## 5 Preferred infrastructure report

### 5.1 Increase in the clearance of the new bridge over The Terrace

**Figure 5-1 Change in height of bridge and approach road – southern bank**

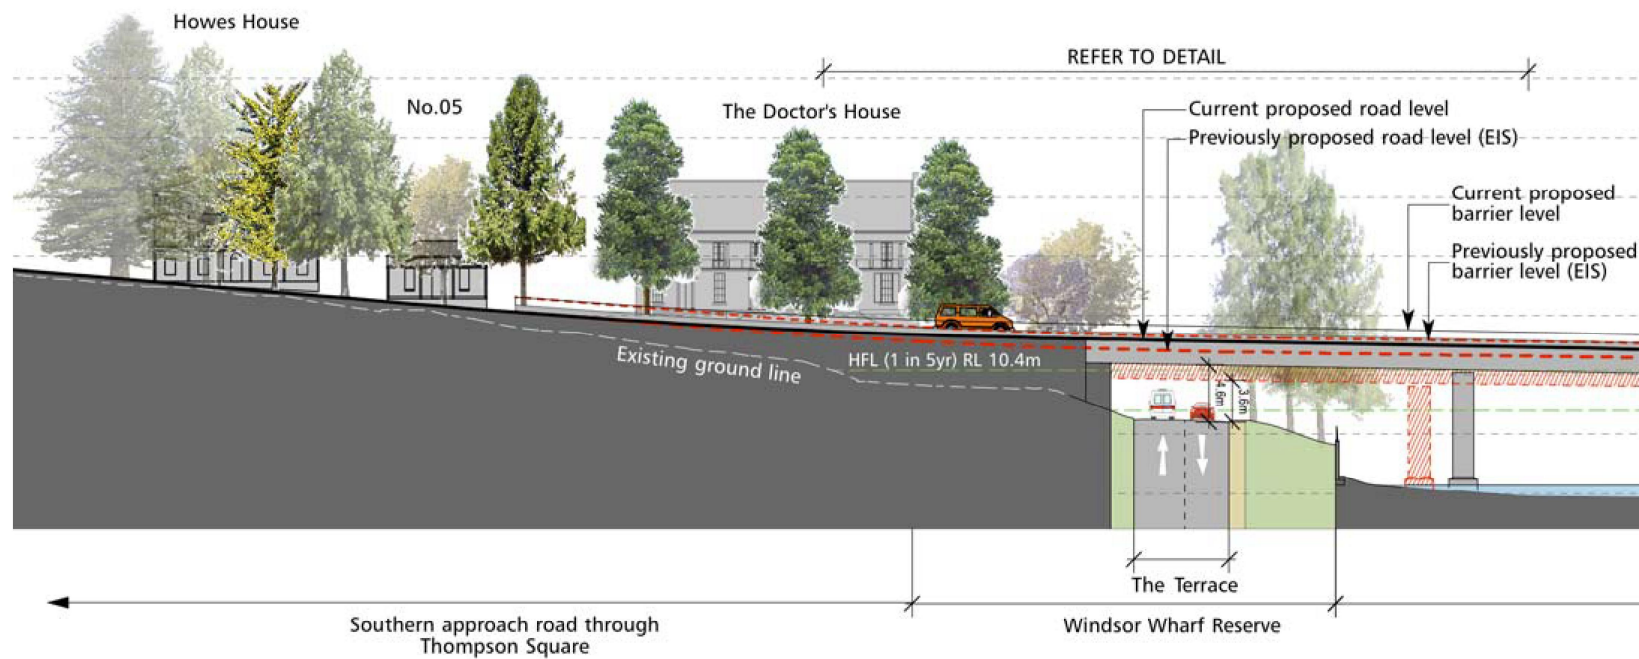
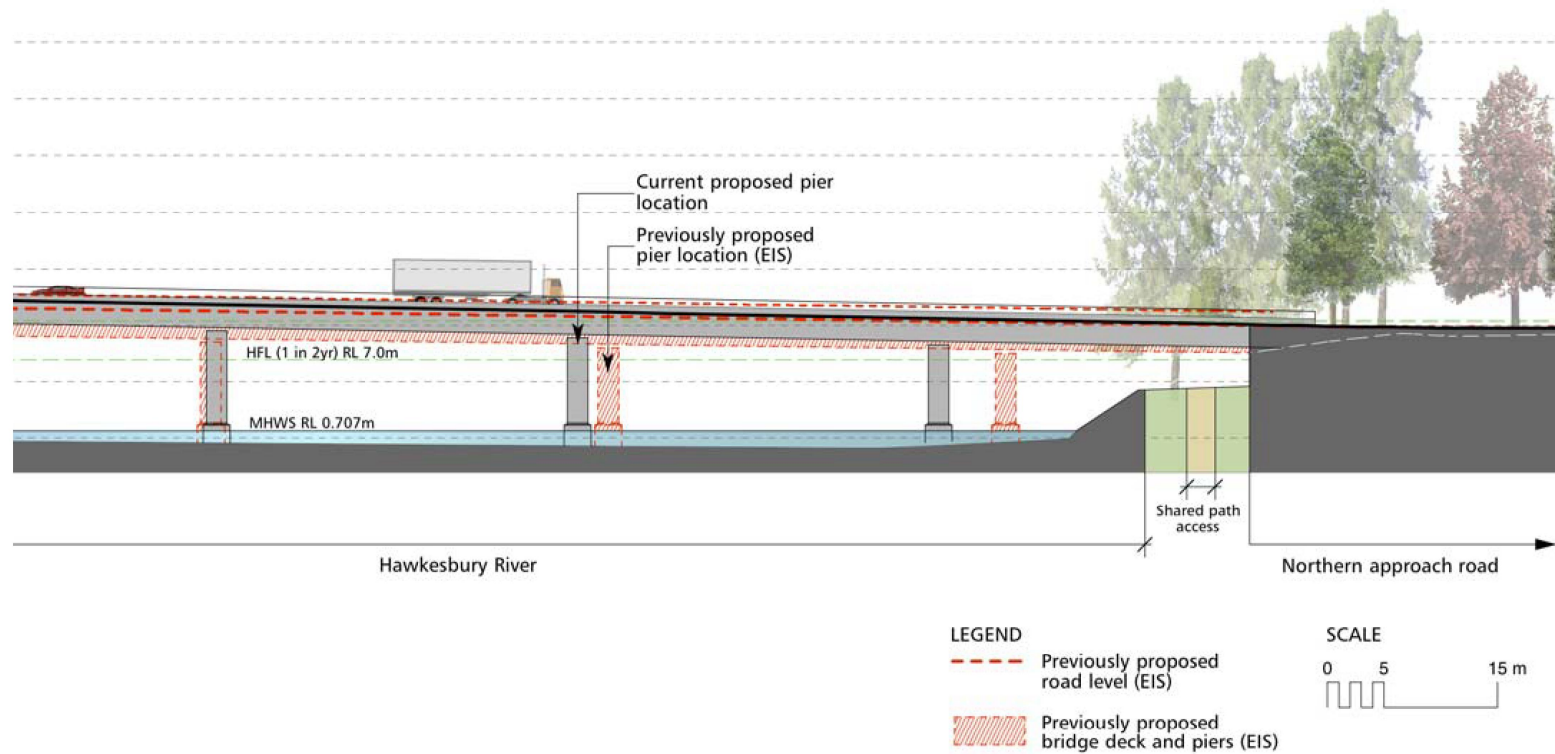
To provide the additional clearance over The Terrace, the height of the southern end of the bridge would be increased. This would result in a one metre higher bridge and abutment at the southern end, and a marginally higher 45 metre long section of the southern approach road through Thompson Square between the driveways of Number 4 Bridge Street to the southern abutment. South of the driveway of Number 4 Bridge Street and in front of the heritage listed properties of Number 6 and Number 10 Bridge Street, the height of the southern approach road would remain the same as that presented in the EIS. The grade of the bridge would also increase slightly from 1.6 to 1.9 per cent.

**Figure 5-1** and **Figure 5-2** presents the difference in heights of the modified project in comparison to the project presented in the EIS.

**Figure 5-4 Changed pier locations – Note grey indicates original pier location and black indicates new pier location**

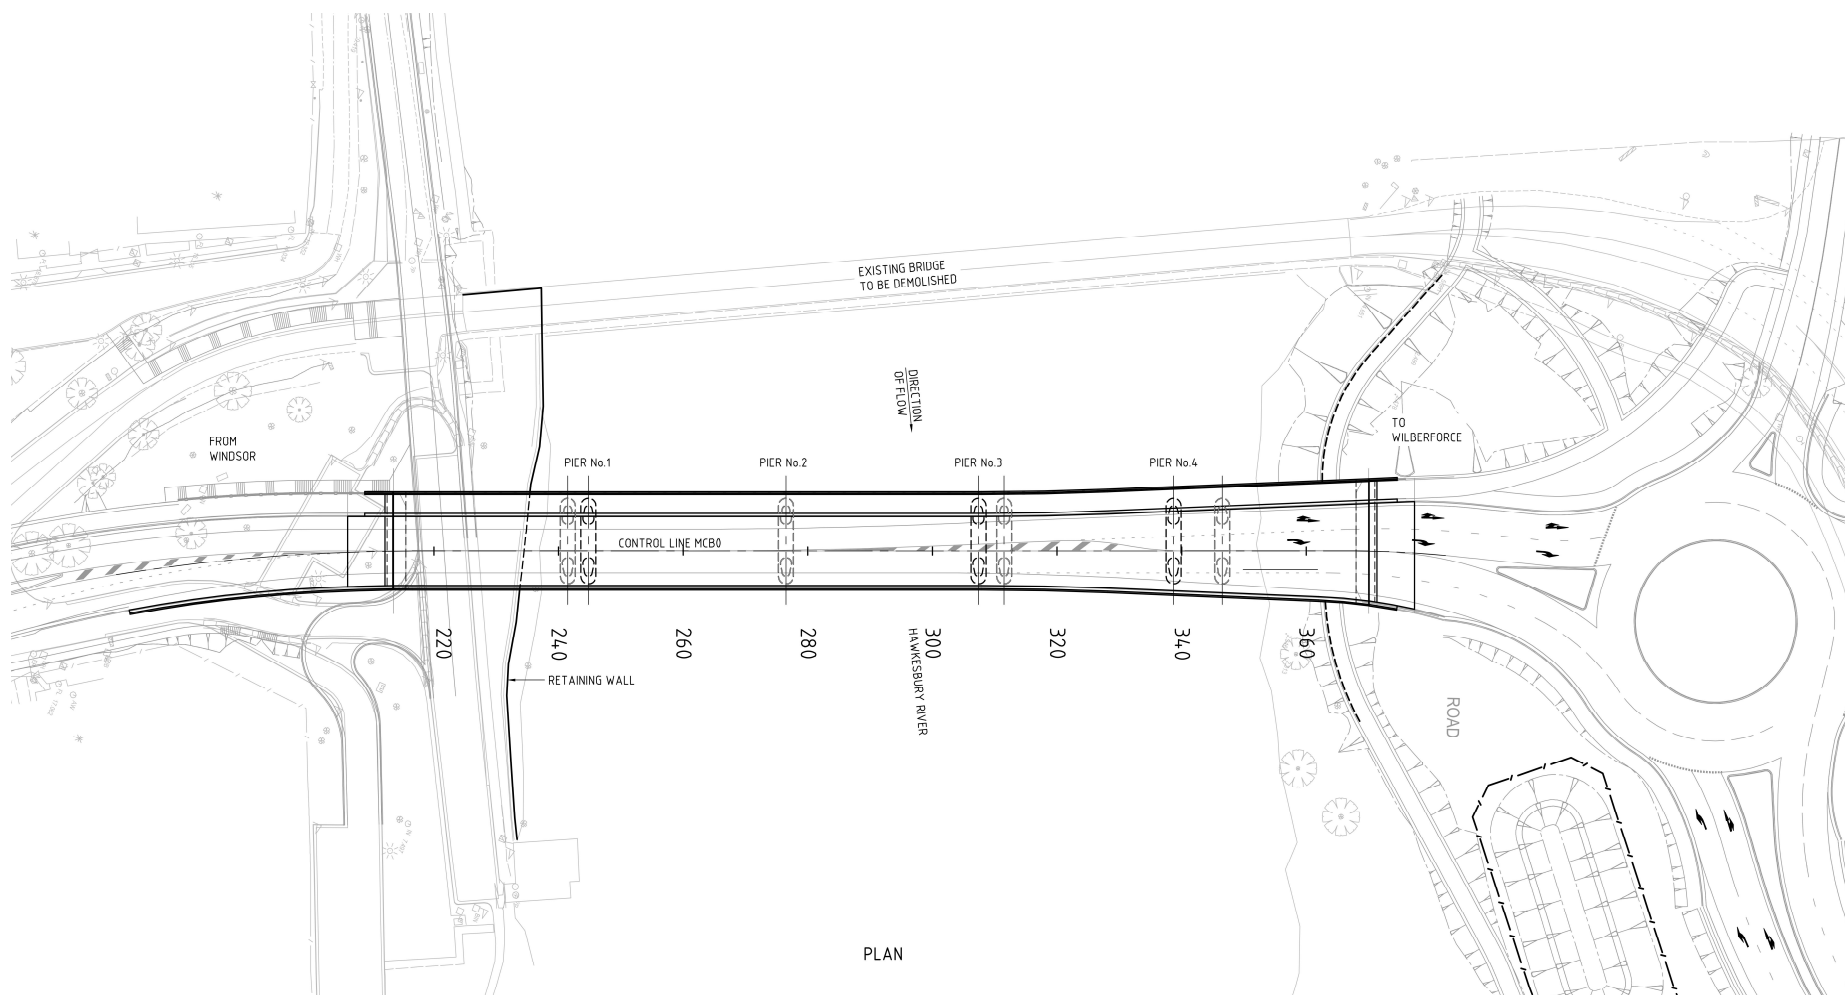
- Instead of a double box girder bridge as shown in Figure 5-4 of the EIS, a double T bridge would be constructed. A double T bridge would have a slightly shallower superstructure than a double box girder bridge but would otherwise have similar features to those described in the EIS. It would be incrementally launched as described in the EIS. **Figure 5-3** shows a cross section of the double T bridge.
- To accommodate the double T bridge, the location of the bridge piers in the Hawkesbury River would change slightly from those presented in the EIS. The changes in pier locations are presented in **Figure 5-4**. The southern and northern piers closest to the respective river banks would be located further from the banks and there would be a minor change in location for one of the central piers.
